TYPE NO FB 7300	TYPE Coffe Vending Machines	T.I. NO 06 - 2015				
SERIAL NUMBERS AFFECTED From and including S/N 50611679	ISSUED BY Documentation/N&W Valbrembo					
SUBJECT NEW AGITATION WIRE FOR COFFEE POWDER	ISSUED FOR (X): <table border="1"> <tr> <td>Action</td> <td><input type="checkbox"/></td> </tr> <tr> <td>Information</td> <td><input checked="" type="checkbox"/></td> </tr> </table>		Action	<input type="checkbox"/>	Information	<input checked="" type="checkbox"/>
Action	<input type="checkbox"/>					
Information	<input checked="" type="checkbox"/>

**Old agitation wire (short)
Picture 1**

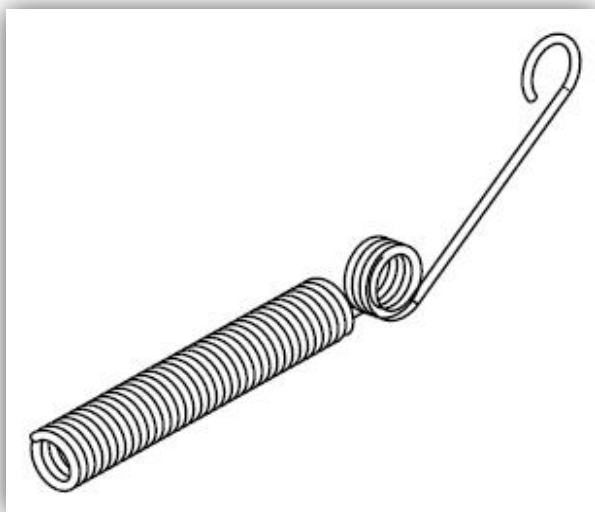
Breaking of the short agitation wire, used in the dual FB canister assembly

The short agitation wire (pre-modification, see picture 1) has been replaced by a stronger agitation wire design (see picture 2).

This new agitation wire is specific for coffee powder and it ensures greater resistance and better dose accuracy.

The **new agitation wire** spare part code is

259501

The **old agitation wire** spare part code is

39283500 (it is no longer available)

The new agitation wire can be installed in the machines prior to the above mentioned serial number.
